PERMIT NUMBER: B 21000796

RESIDENTIAL BUILDING PERMIT APPLICATION

Street Address: 12255 Blue Sky Evening Way Unit: _____
 City: **Fulton** State: **MD** Zip Code: **20759**
 Subdivision/Village/Complex Name: **Fulton Woods** SDP/WP/BA #: **GP-19-041**
 Lot: **Lot 4** Tax Map: **0041** Parcel: **0199** Grading Permit #: **G18000297**

From: Davis, Michael J
Sent: Monday, June 7, 2021 8:50 AM
To: Oswald, Hank
Cc: Williams, Jeffrey
Subject: RE: B21000796_12255 Blue Sky Evening Way_Lot 4_Floor Plans

FIRST FLOOR PLAN

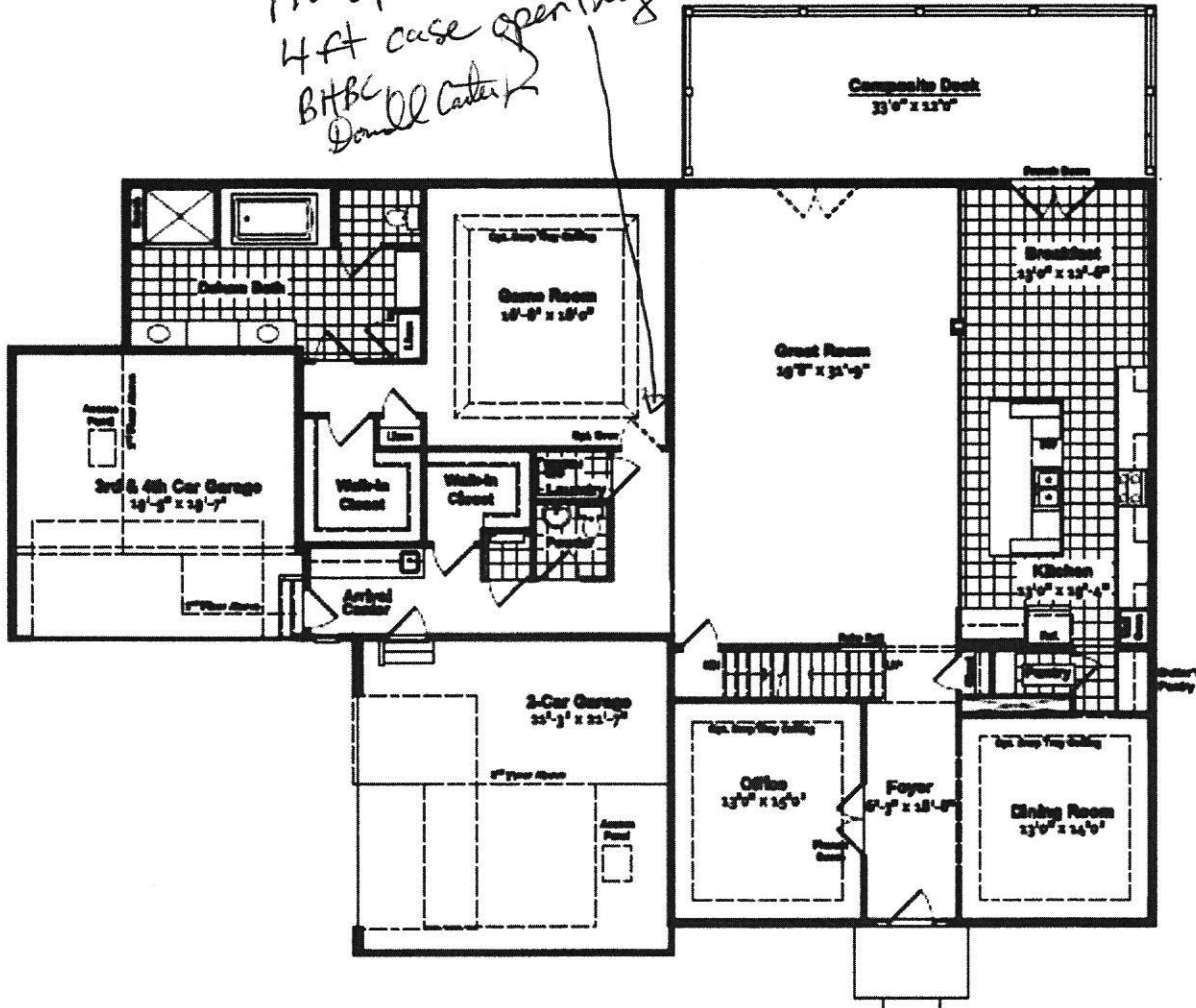
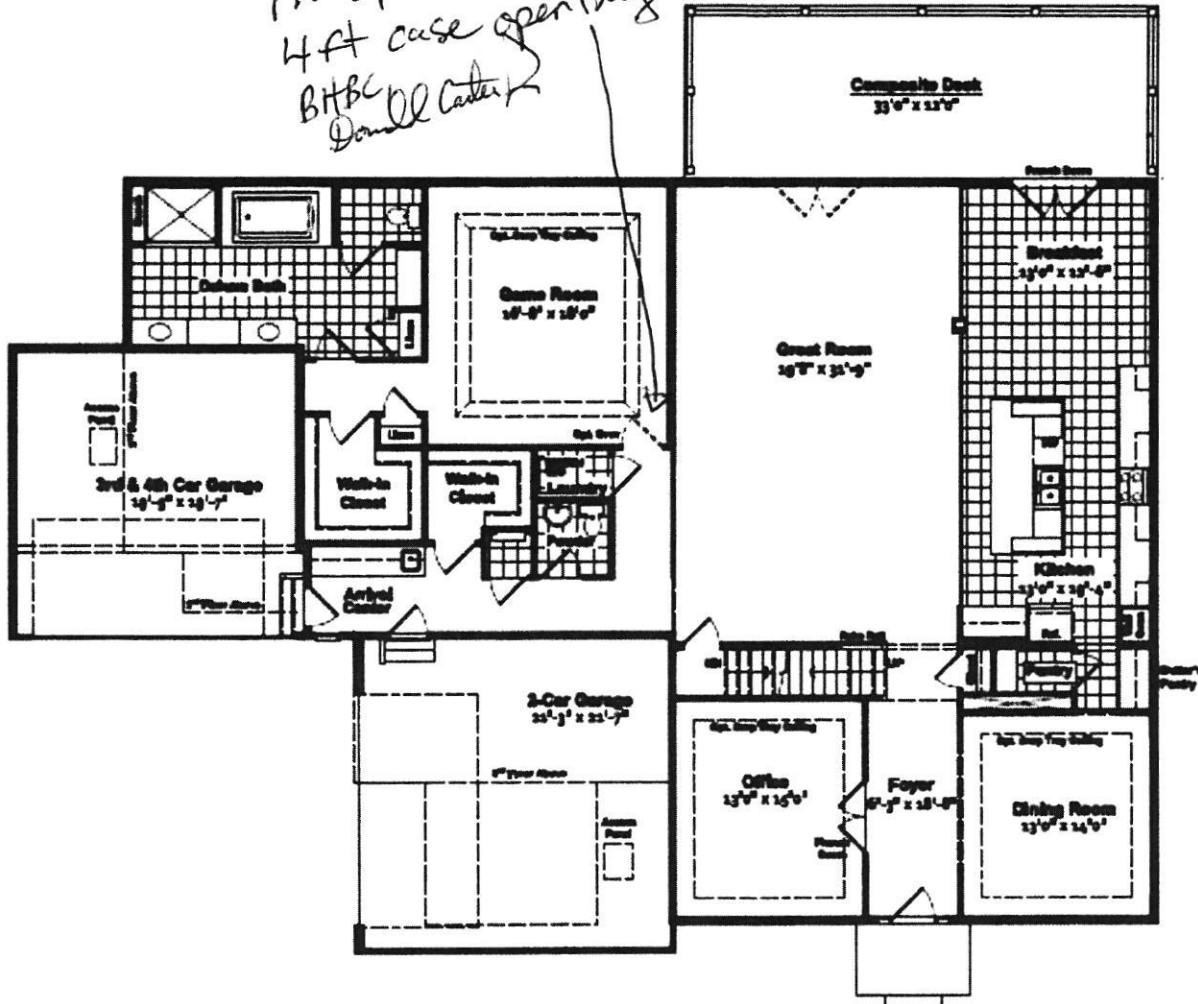
Hello Mr. Carter. I wanted to jump in here because I am confused how the first floor game room could have a 4' cased opening in a hallway that does not appear to be 4' wide.

Today, I received a floor plan for the 1st floor only (Lot 4) through DILP. The floor plan still shows a door into the game room. The size of the opening (less than 4 ft.) into the game room plus the door makes it a bedroom. As mentioned in April, I need a simplified floor plan (basement, 1st and 2nd floor) submitted through DILP showing 4 bedrooms.

*No optional door
4ft case opening
BHBC
Donald Carter*

Thanks so much for the update. We'll get you a signed OSDS plan today for Lot 4. I requested only the OSDS plan for Lot 4 and was told by then engineering that they were giving me 4 copies of that plan. My apologies for taking their word and not verifying. Regarding the number of bedrooms, we have stated on multiple occasions that the Theater Room doesn't have a window and the 1st Game Room & Basement Den have 4ft cased openings i.e. no doors. Please see the attached document.

OPTIONAL FINISHED LOWER LEVEL*

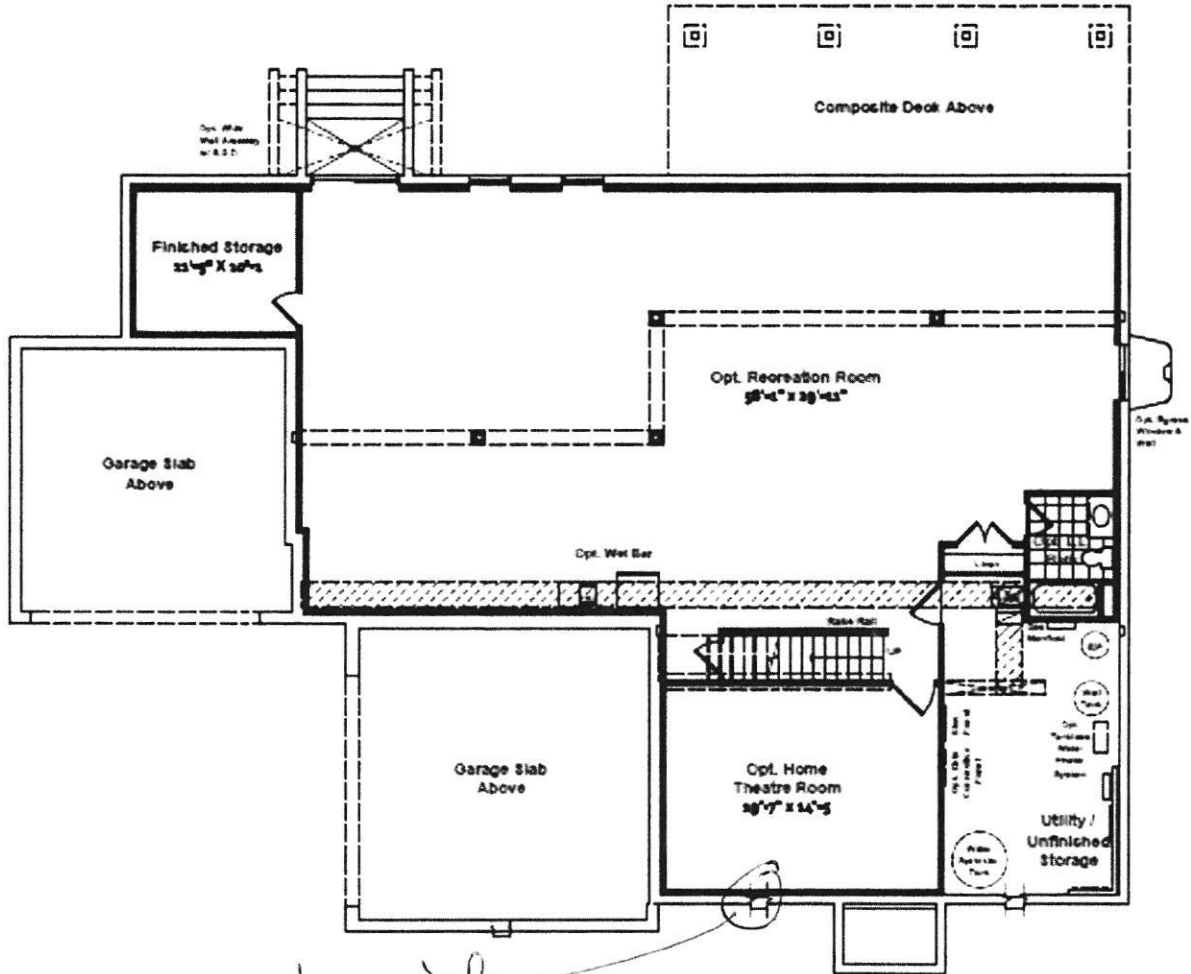
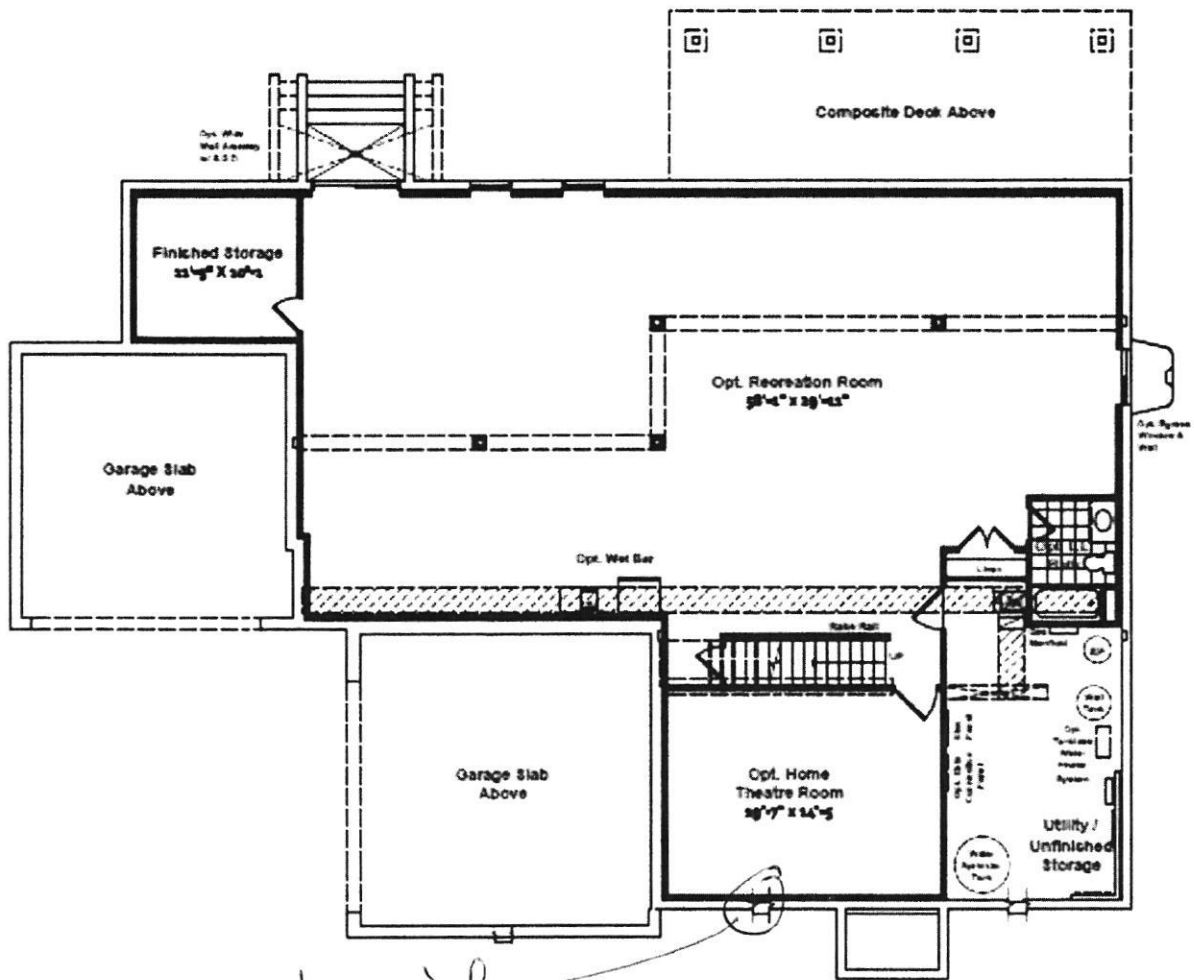
Lot #4 Floor Plan - The correct building permit # for Lot #4 is B21000796. The floor plans (attached) that you sent me for Lot #4 shows 6 maybe 7 bedrooms. Does the theater room on the lower level have a window? The OSDS Plan for Lot 4 is designed for 5 bedrooms. I confirmed with the engineer this morning that there isn't enough room for more bedrooms in the design, so the floor plan for Lot 4 will need to be revised and submitted through DILP with 1 copy labeled for Health Department.

not a window
shows optional brick ledge
BHBC, Donald W. Gates

SEPTIC SETBACK EXHIBIT
FULTON WOODS

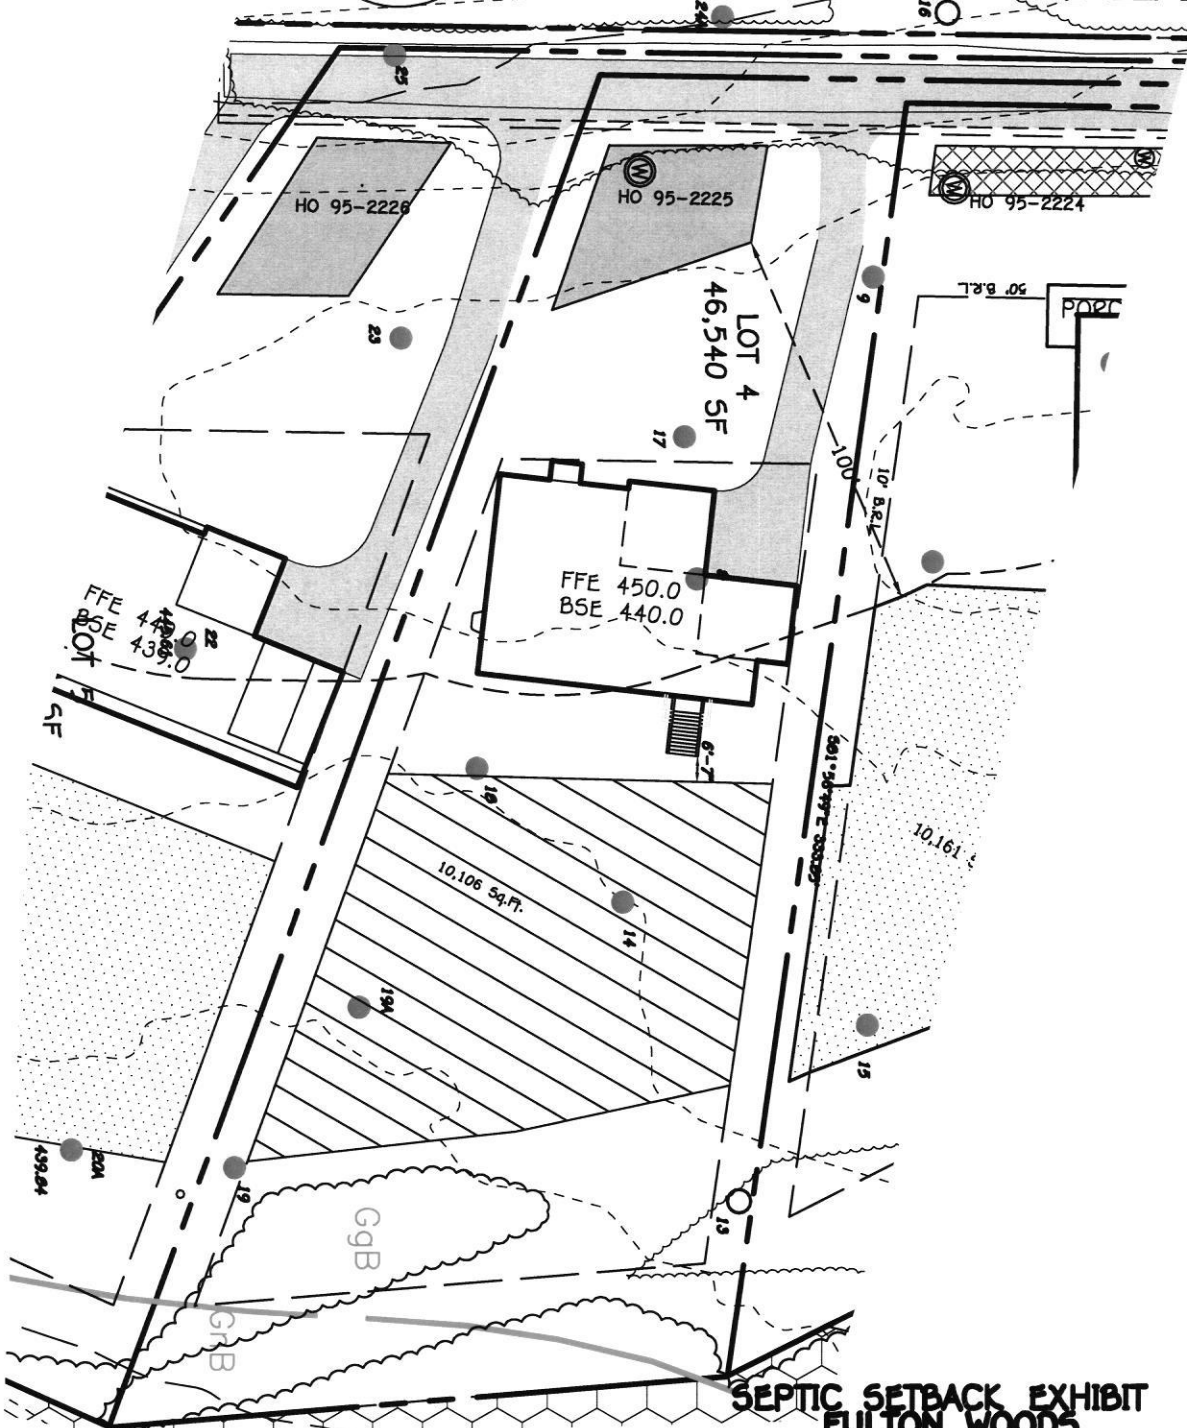
As the owner and builder we are requesting a septic field adjustment/variance for Lot 4 at Fulton Woods to reduce the distance of the septic field setback to approximately 6.58 feet. Please see the attached drawings for the details.

This adjustment is being requested because the home to be built is larger than originally planned and can not be repositioned to solve the septic setback requirement, there is a failed perc in the left rear of the current septic field, and given COVID this project can not afford the cost or risk of an additional perc test. The foundation under the Sunroom is basement. In summary, this is the best solution given all of the criteria.
